December 2, 2016

SUBJECT: **Modification Request of Section 404 Regional General Permit No. 31 and Section 401 General Water Quality Certification No. 3886** for the proposed Interstate 85 (I-85) Widening and Interchange Improvements from north of NC 73 (Davidson Highway / Exit 55) to north of SR 2180 (Lane Street/Exit 63), Cabarrus & Rowan Counties, Divisions 9 and 10. Federal Aid Project No. FANHIMF-085-2(61)55, TIP Project No. I-3802A.

PERMIT DRAWING
SHEET 8 OF 128

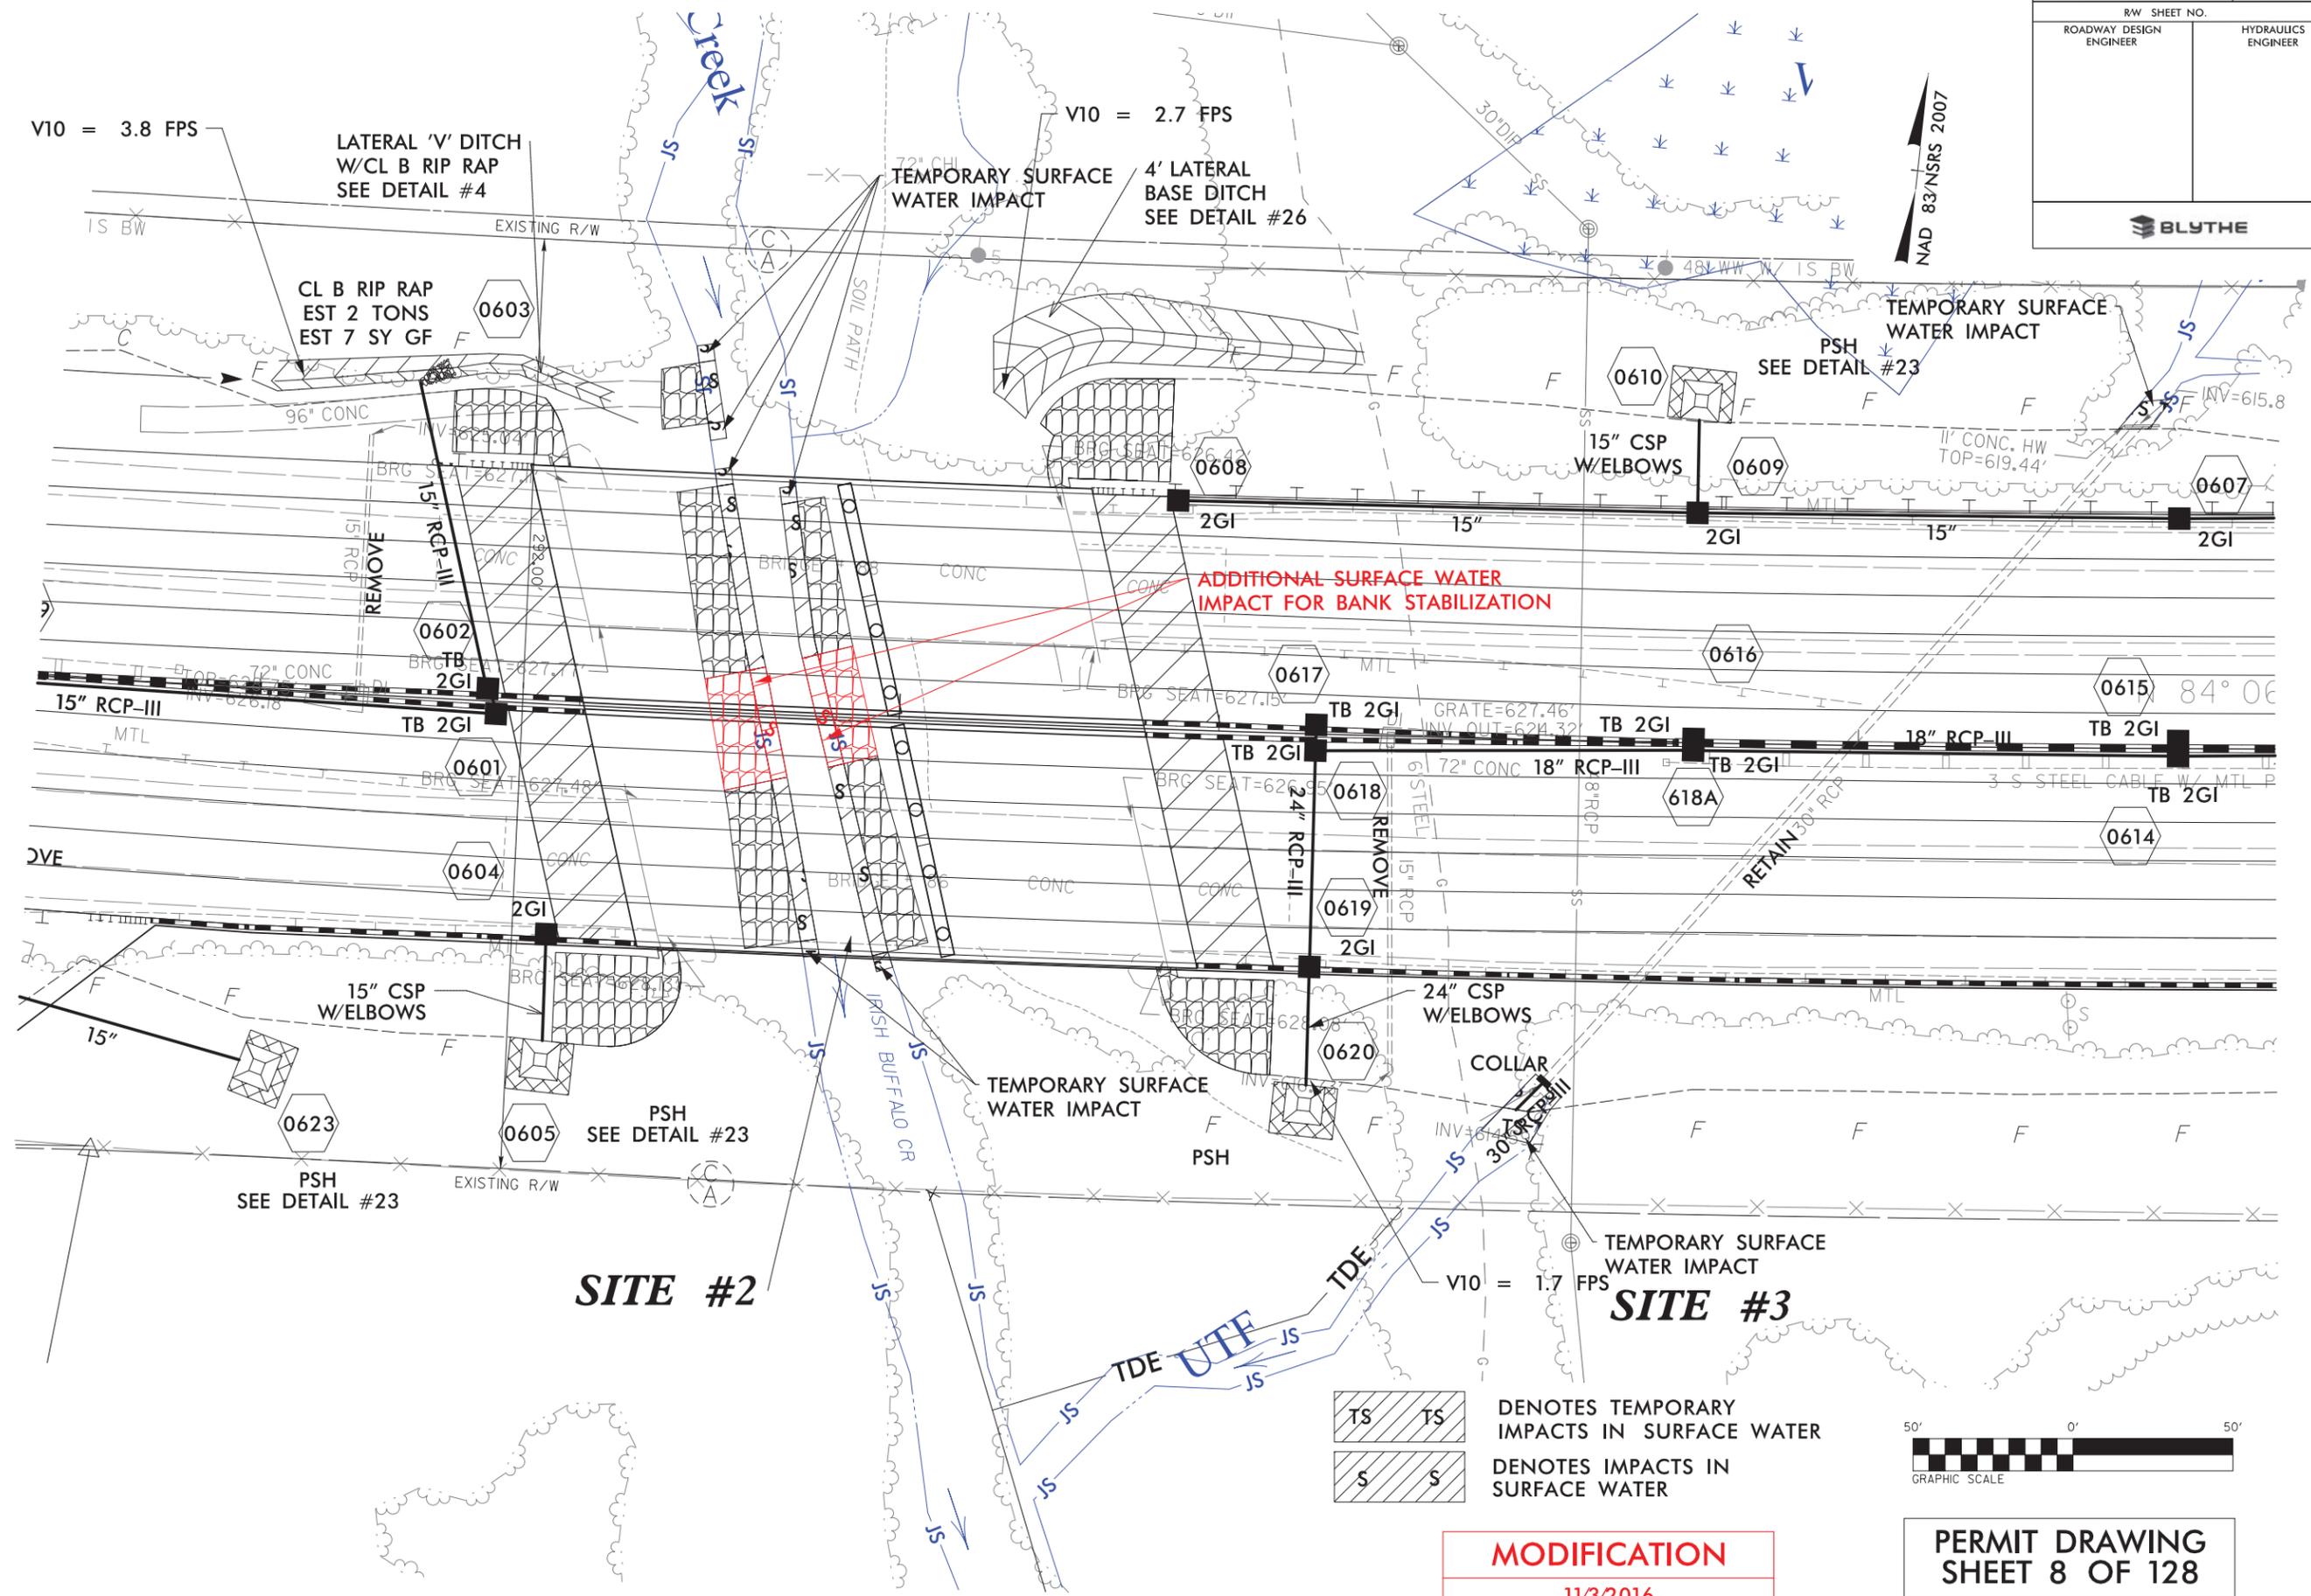
During the same field review for Site 18 on November 17, 2015, Ms. Hood requested that additional riprap be placed on the banks of Irish Buffalo Creek under the existing bridge to prevent erosion from existing shading and potential vegetation die-off. As a result, Class II riprap is being proposed at this location with geotextile fabric to be installed between the Class II riprap and the stream bed and stream banks.

Previous Site 2 impacts included 30 linear feet of temporary stream impacts and 137 linear feet of bank stabilization impacts. The additional bank stabilization at Site 2 will result in an additional 35 linear feet of permanent bank stabilization impact. Consequently, the proposed overall total for Site 2, including the previously-permitted impacts and currently proposed impacts will be 20 linear feet of temporary impacts and 172 linear feet of bank stabilization impacts. As a result of the currently proposed bank stabilization, temporary impacts at Site 2 will decrease from the permitted total of 30 linear feet to 20 linear feet due to the elimination of two 5 linear foot sections of temporary impact. No other changes to permitted wetland and stream impact are proposed for Site 2.

PERMIT DRAWING SHEET 61 OF 128

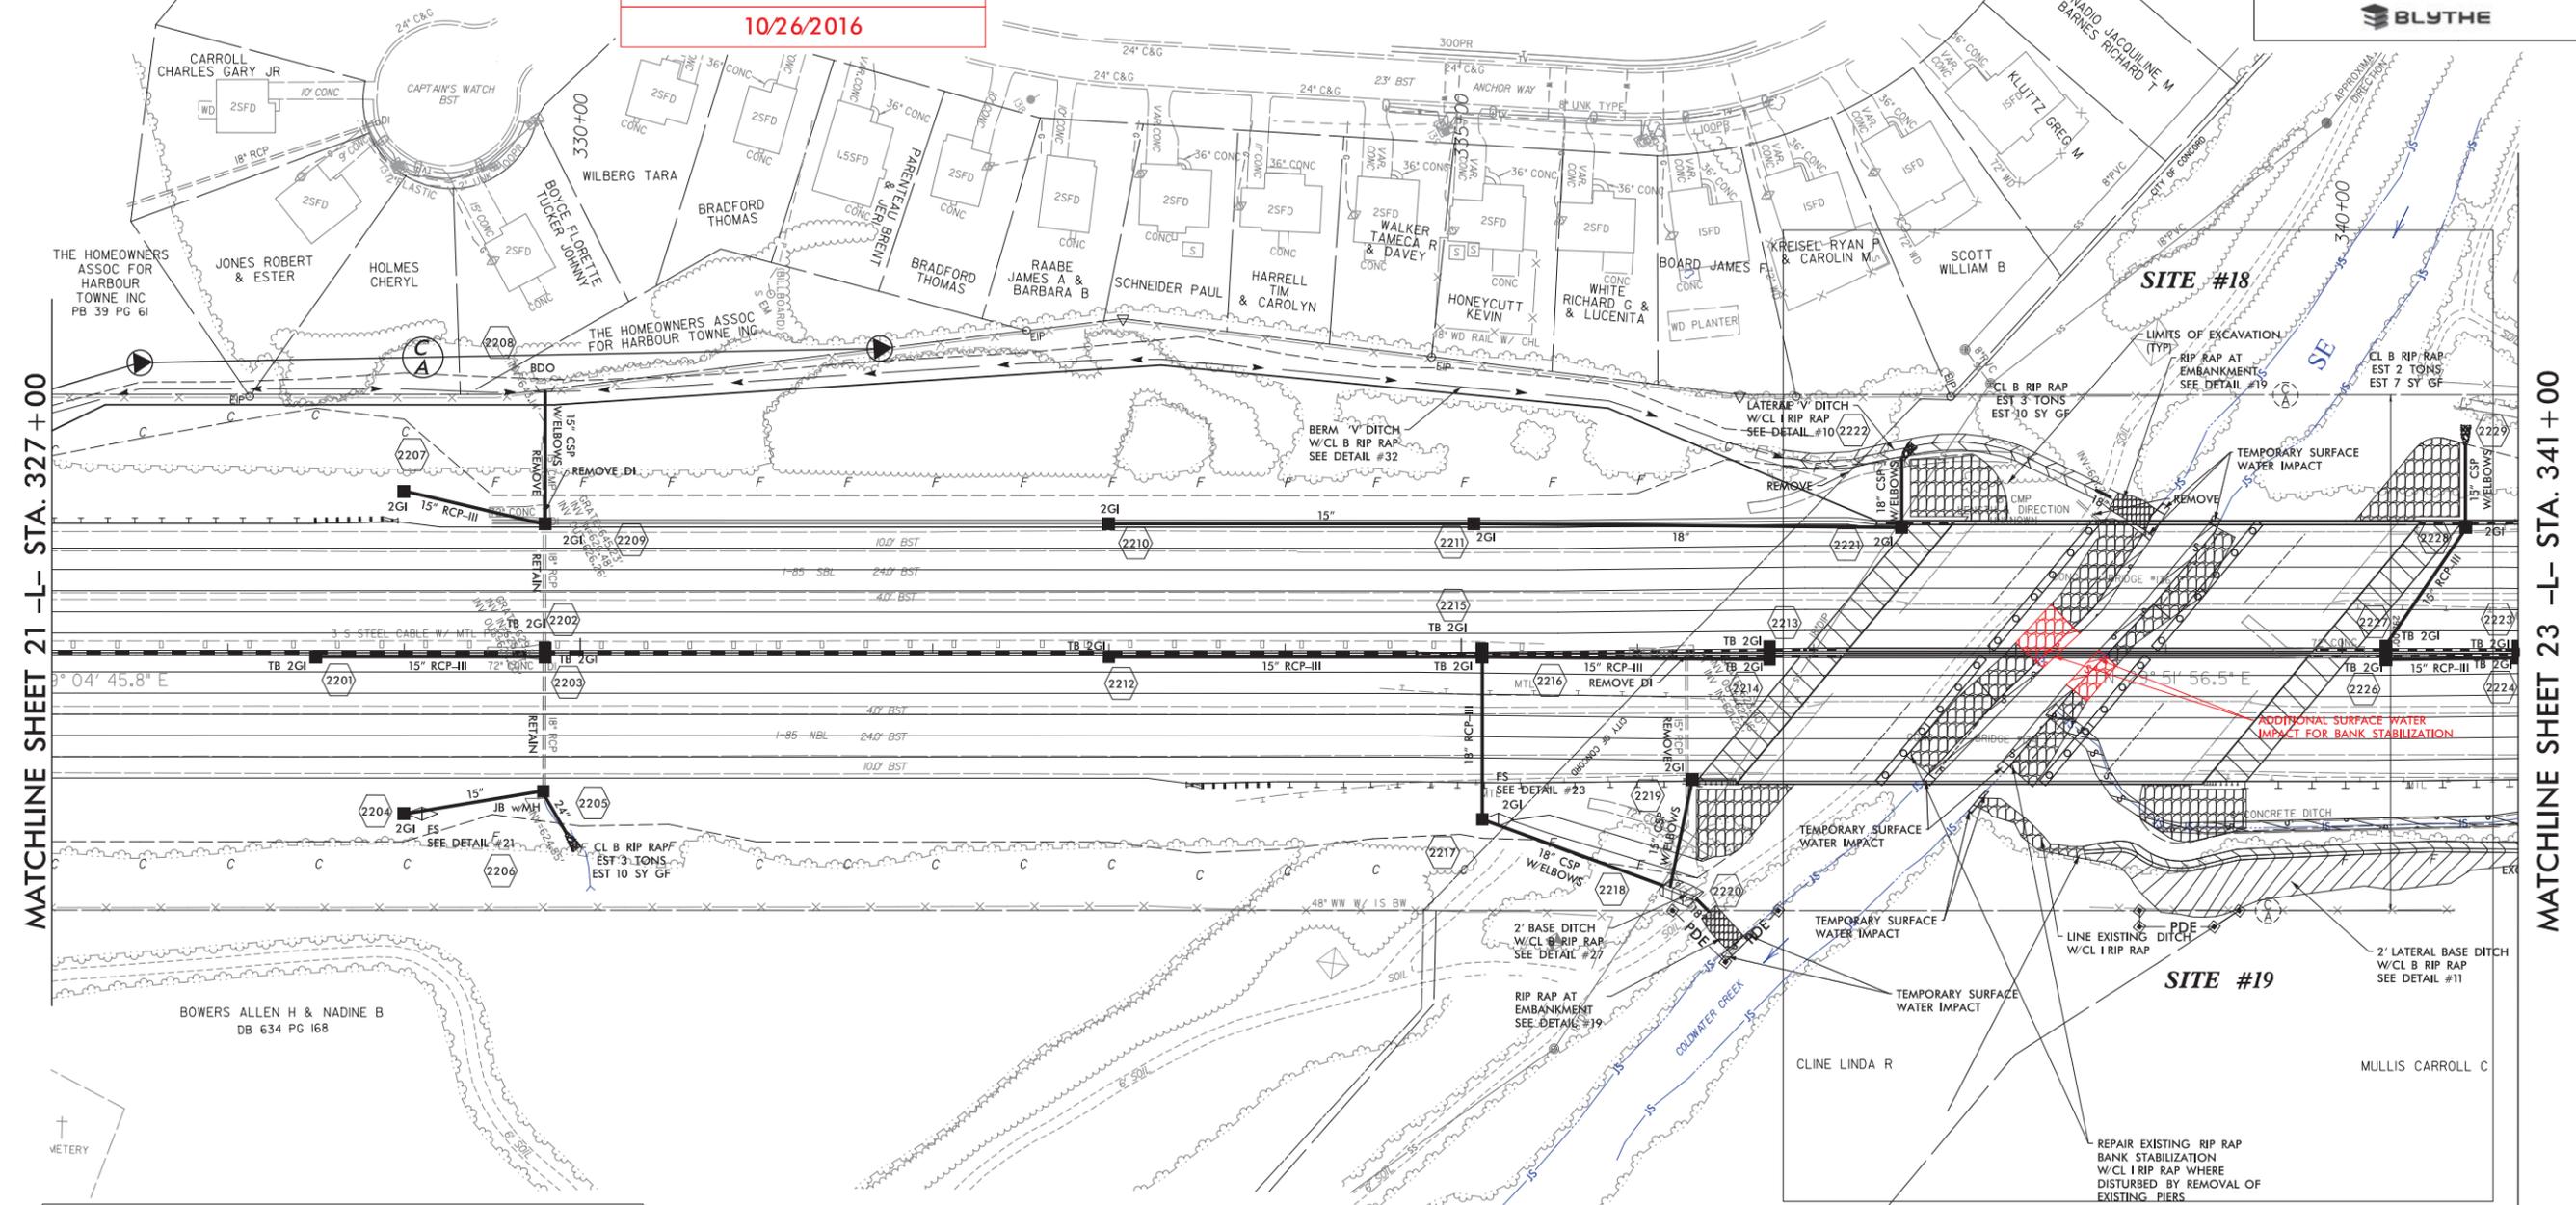
On November 17, 2015, representatives from NCDOT met on site with Ms. Donna Hood (N.C. Division of Water Resources [NCDWR]) to conduct a project review. During the site meeting Ms. Hood recommended that additional riprap be placed under the Cold Water Creek Bridge. The contractor also required a temporary crossing at the same

location. A modification request for the addition of 66 linear feet of temporary stream impact due to the placement of the temporary causeway and 30 linear feet of permanent impact due to bank stabilization at Site 18 was initially requested on February 18, 2016. The modification to the Section 401 certification was approved by NCDWR on March 22, 2016. The Section 404 modification request has not yet been approved by the U.S. Army Corps of Engineers (USACE). Since the February submittal, it has been determined that the temporary crossing is no longer needed. Additionally, the riprap bank stabilization was installed at the site by the contractor prior to receiving the USACE permit modification, most likely due to a misunderstanding that both the Section 404 and 401 modifications had been approved. The previously approved 185 linear feet of stabilization, which was permitted by the original permit, and the additional un-permitted 30 linear feet included in the last permit modification request has already been installed at the site.
